Walking SA's Feedback

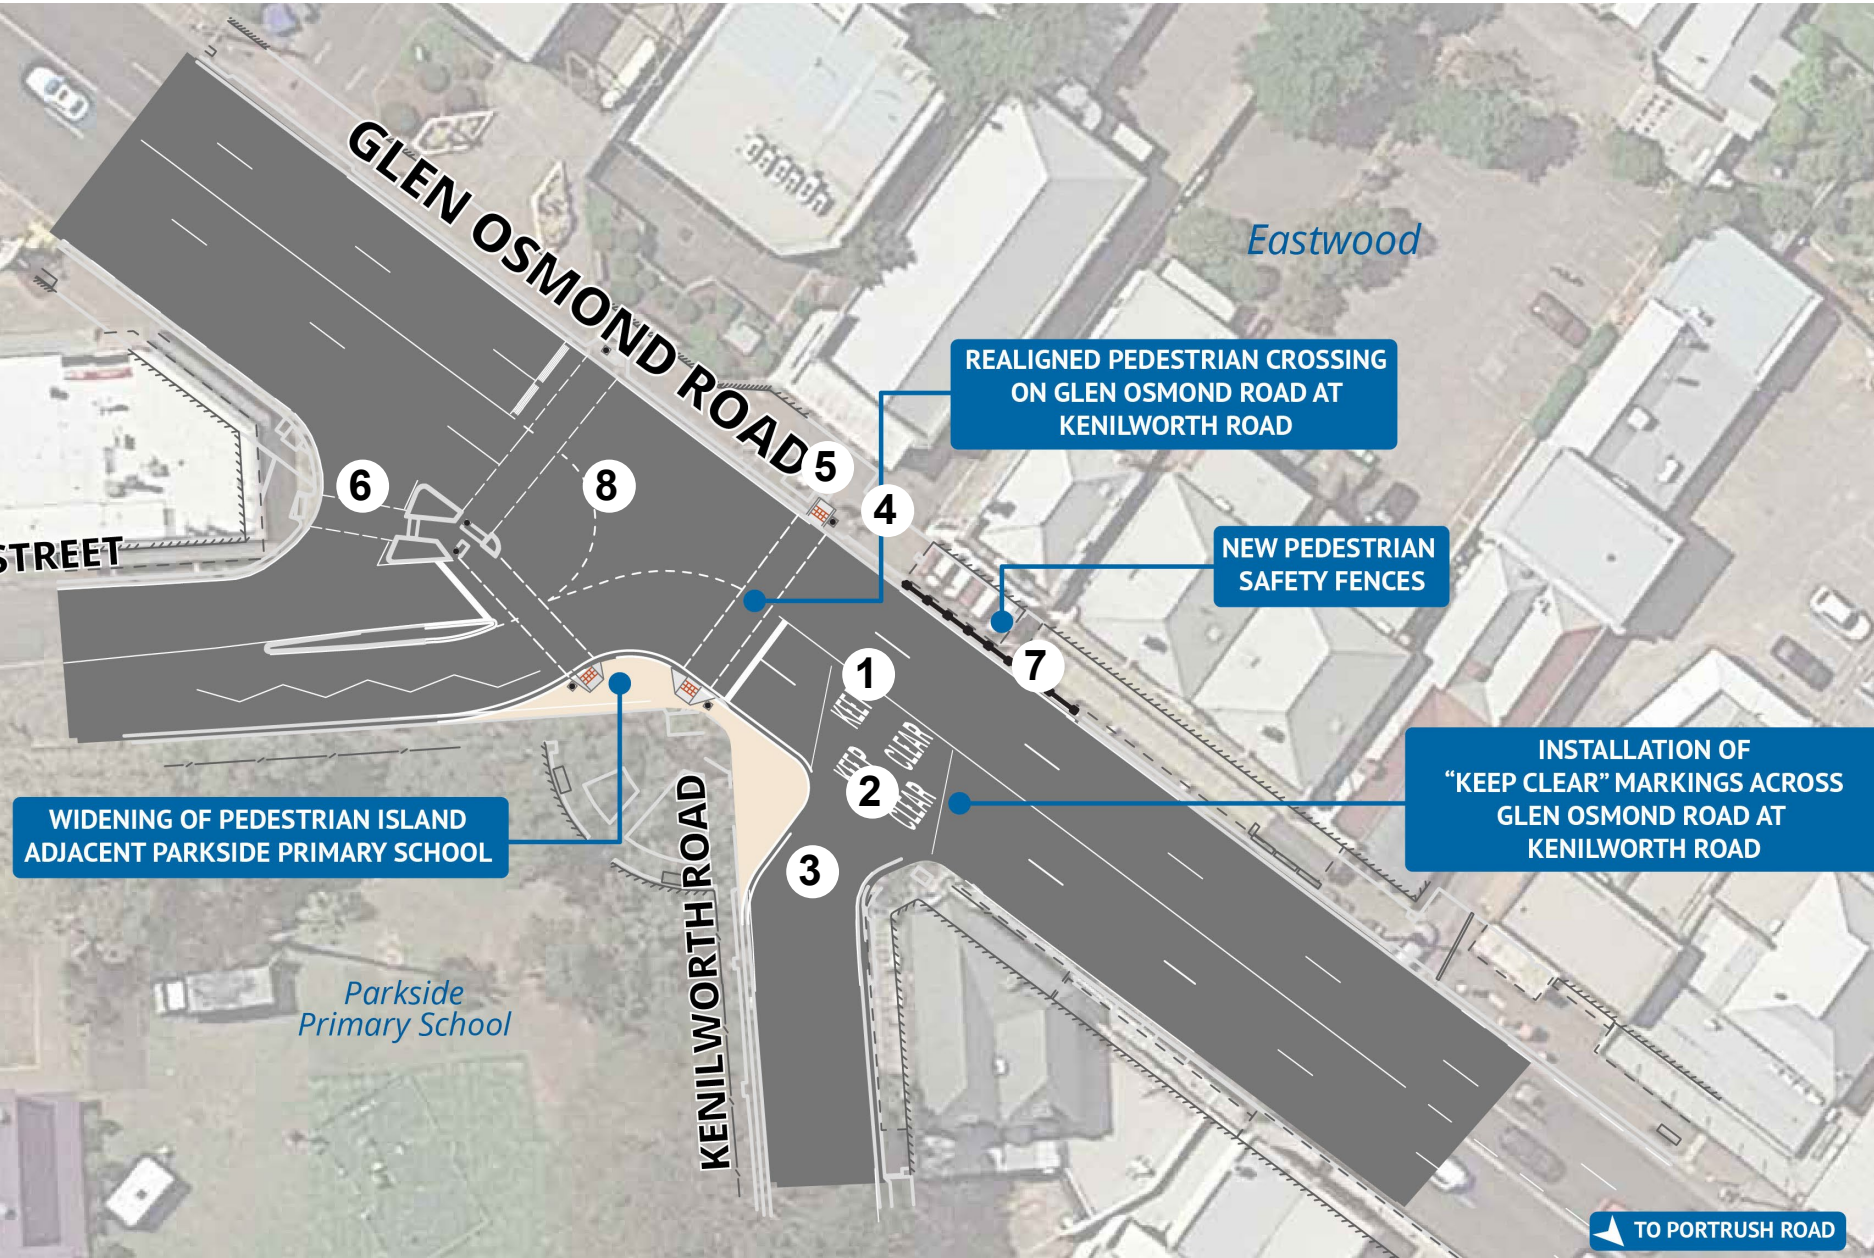
- 1. Right turns into Kenilworth Road:**
Walking SA have concerns with maintaining right turns into Kenilworth Rd, noting that they were previously signalled, and with the proposed design will be unsignalled. It is considered that queuing that previously occurred within the intersection will now occur just east of the proposed new pedestrian crossing, and across the pedestrian crossing itself. If the 'Keep Clear' is blocked, which is likely noting it's proximity to the intersection approach, this may cause unsafe driver behaviours and conflict between pedestrians wanting to cross Glen Osmond Road and queued vehicles.

- 2. 'Keep Clear' markings:** Although Walking SA appreciate the need for the 'Keep Clear' markings to facilitate right turns into Kenilworth Road, there is significant concern regarding the safety of pedestrians crossing Kenilworth Road. Noting the limited opportunities that right turners will have to access Kenilworth Road (during the busy peak periods), it is likely that right turn movements will become more aggressive, and with queued vehicles may block pedestrian sight lines.

- 3. Kenilworth junction:** Noting that Kenilworth Road junction is a one-way entry point from Glen Osmond Road, Walking SA recommend that DIT undertake further improvements to narrow the Kenilworth Road junction approach including the provision of accessible kerb ramps, landscaping/greening and threshold treatments, such as street print.

- 4. Art shop driveway accessibility:** It is not clear from the concept design presented how the Art shop driveway will be managed. Will right turns into and out of the Art shop be restricted. Will the driveway be upgraded to improve its legibility, noting school children will need to cross the driveway to access the laneway to Main Street (which is the key pedestrian desire line). Walking SA would like DIT to further consider removal of the driveway access point, with access via Main Street, as per the other businesses in the area or at least narrowed and restricted to left in / left out. It is likely that during the busy school drop-off and pick-up periods that pedestrians will end up storing across the driveway.

- 5. Kerb ramp width:** It is difficult to see from the concept design, however the kerb ramp width presents as minimum width of 1.2 metres, and on the northern side is even further limited with upright kerbs. Walking SA would like to see these kerb ramps widened, particularly noting the high pedestrian demand, to at least 1.8 metres.

- 6. Young Street slip lane:** Intersection slip lanes are a poor pedestrian design outcome that is aimed at prioritising vehicle movements. Walking SA would like to see the slip lane removed and the space returned to public realm. At a minimum, the slip lane should be designed to be a raised wombat to prioritise movements by people walking and calm traffic.

- 7. Pedestrian fencing:** Pedestrian fencing is also a poor pedestrian design outcome, and typically applied when pedestrians are not accommodated from a desire line perspective (that is, the designed pedestrian crossing point, doesn't take pedestrians to where they want to go). It is noted however, that schools often request pedestrian fencing, as it is a perceived safety measure. If pedestrian fencing is required for this project, the design of the fencing should be considered, such that it contributes to the amenity of the street.

- 8. 40km/h School Speed Zone:** To improve safety around all schools (primary and high) that front busy arterial roads, Walking SA encourages DIT to consider installing 40 km/h School Speed Zones to calm traffic and increase motorist awareness of the school and the higher than normal pedestrian activity during school drop-off and pick-up times. This section of Glen Osmond Road is an ideal location for a 40 km/h School Speed Zone and should be considered as part of the design.
